DEVELOPMENT REVIEW BOARD
TRANSPORTATION DEVELOPMENT
Standard Comment Sheet

DRB- 1005452 Item No. 18 Zone Atlas D-10

RE: Tract 1, Volcano Cliffs, Unit 17/sketch

DESCRIPTION OF REQUEST: Sketch Plan review - Volcano Heights Sector Plan

Site Plan

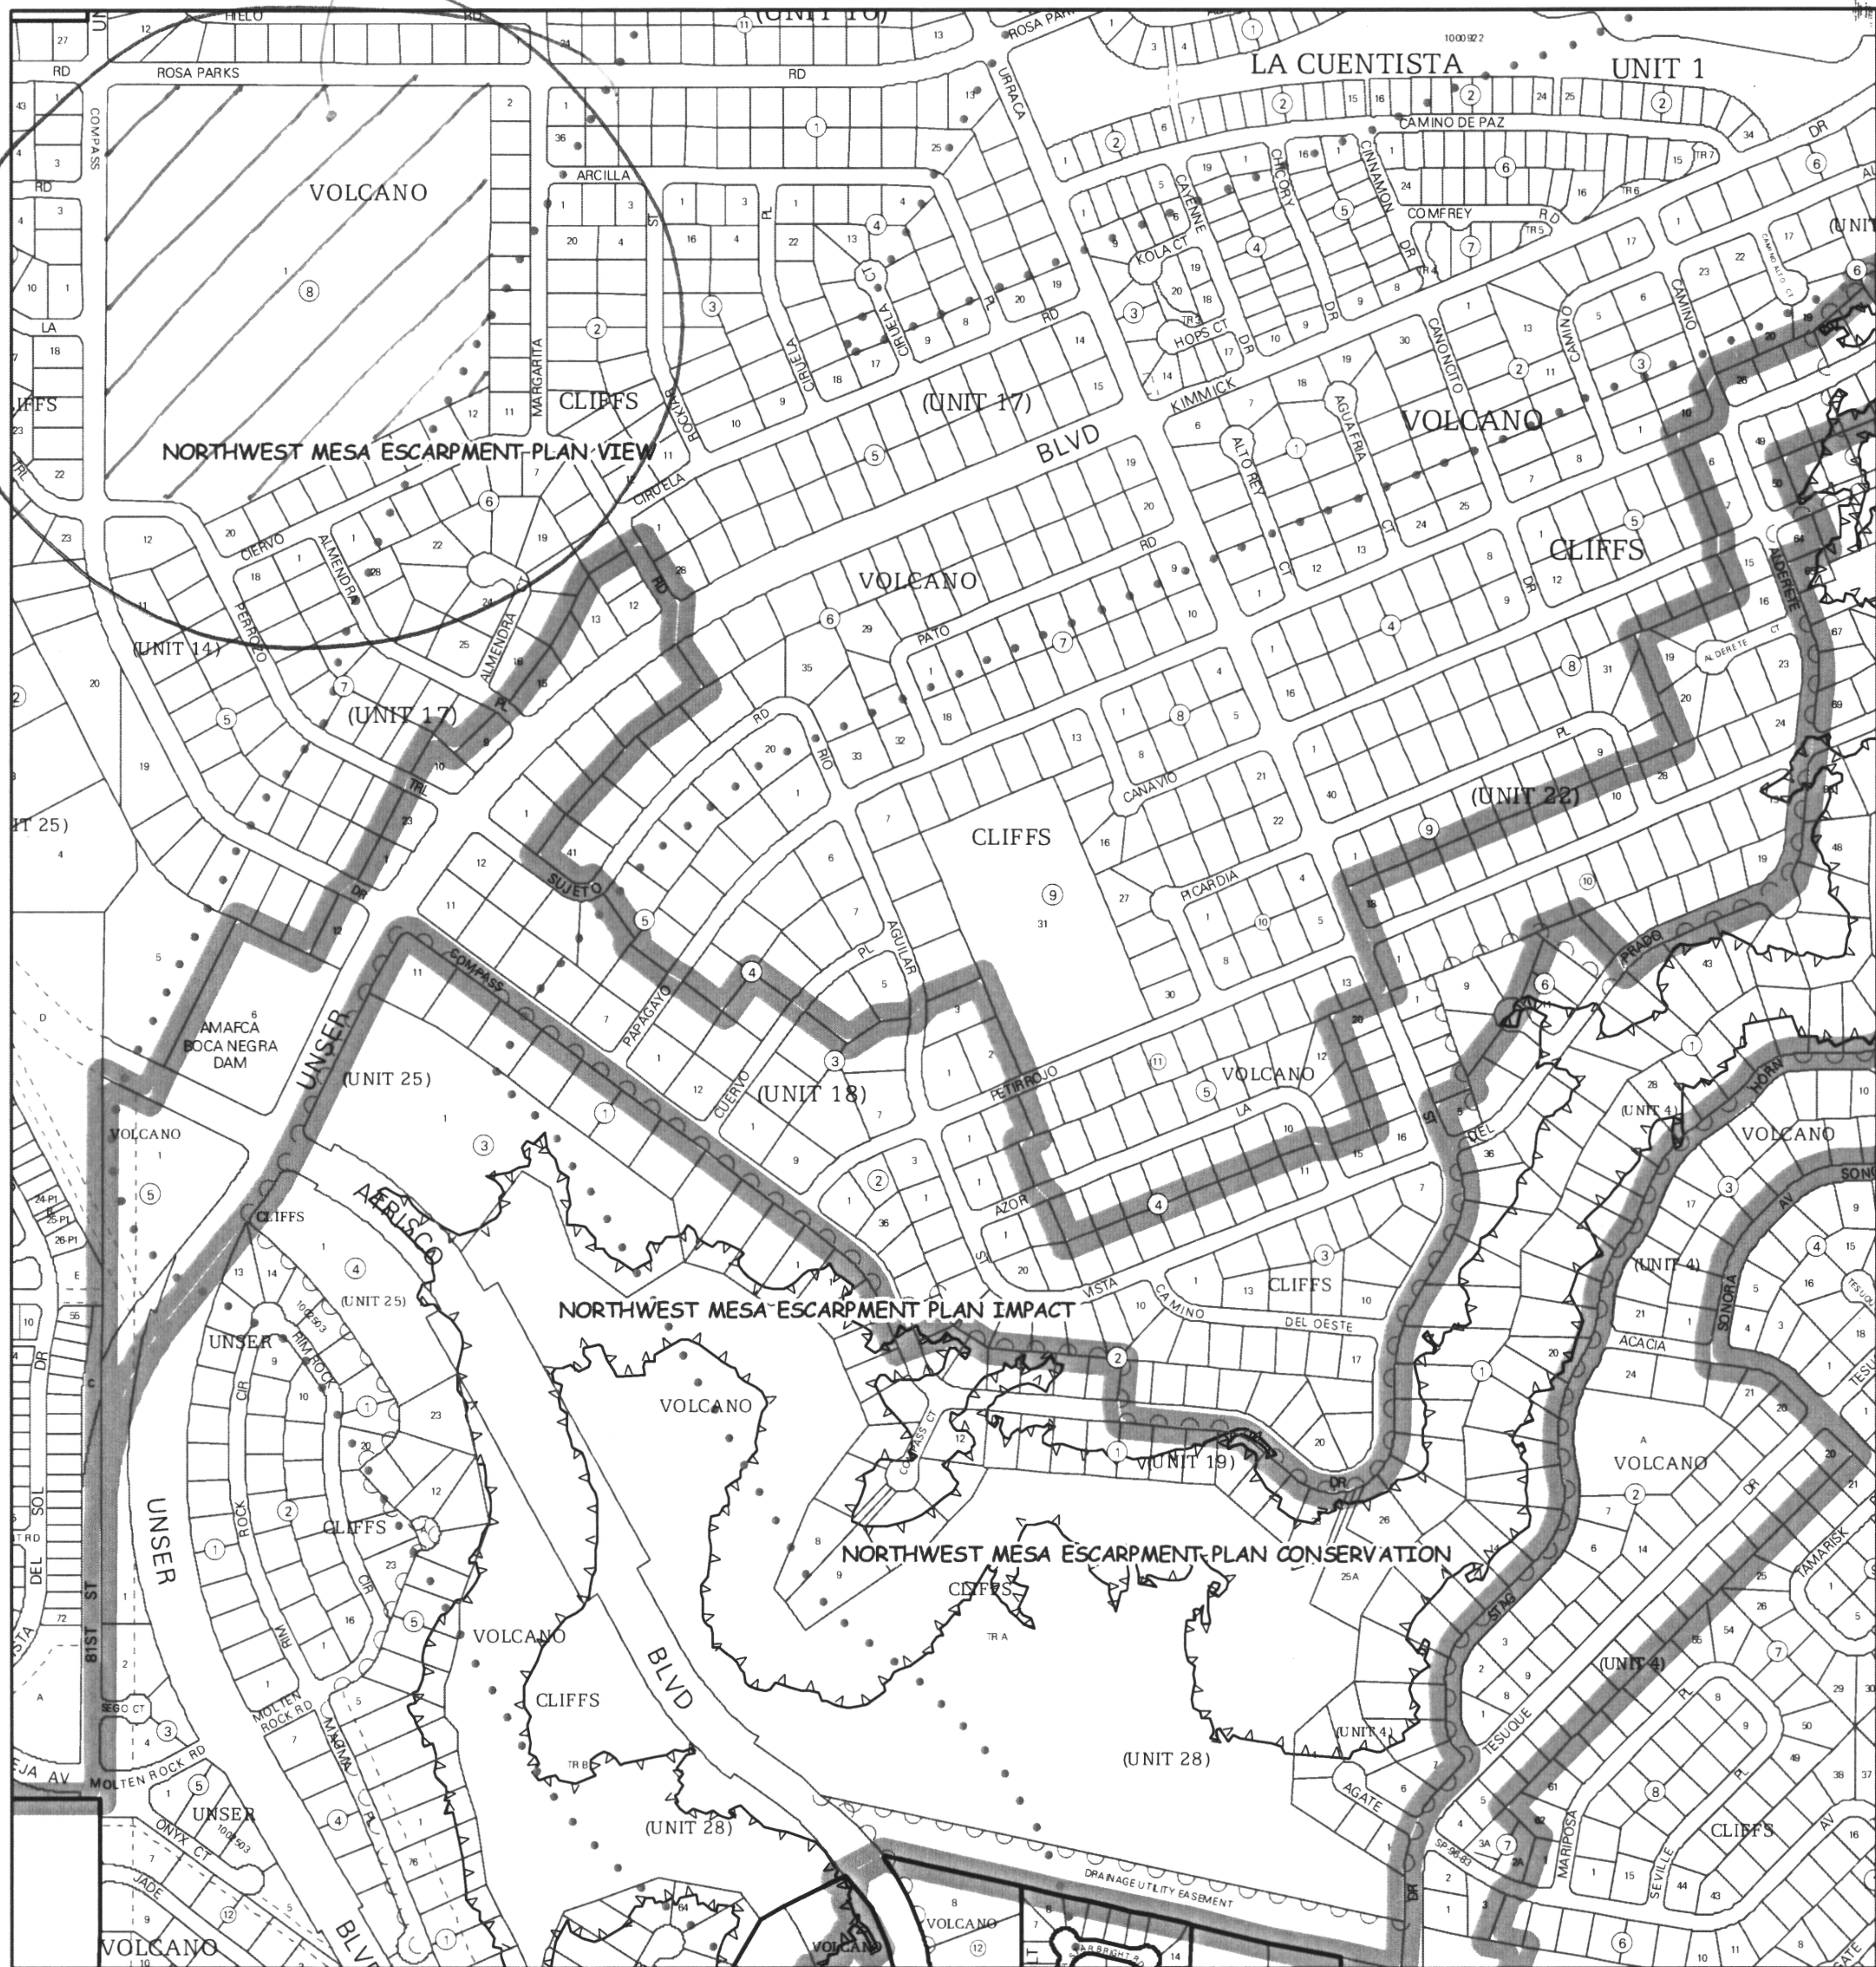
<u>No.</u>	<u>Comment</u>
1)	A TIS will be required.
2)	An analysis of the street right-of-ways and cross-sections will be needed. (Why is Unser only 30'?)
3)	Access on Universe needs to line up with the previous platting to the west.
4)	A queing analysis will be needed to support the access on the south side.
5)	Interior cross sections will need to be per the VHSDP.
6)	More comments will be made as the plan progresses.

The property is known as the Volcano Cliffs Village Center in the Volcano Heights Sector Plan. The zoning is SU2 for Village Center according to the sector plan. A zone change is only required if the applicant desires a different zoning.

EPC is the approval body for this village center. (See IMP-10 of Council amendments.) The site plan approvals should include both site plan types... subdivision and building permit.

Land Use Map C indicates park land on the east side of the property.

It is likely that a platting action is also required. DRB approves the subdivision of property.

Refer to the Sector Plan in developing the site plans and plat.
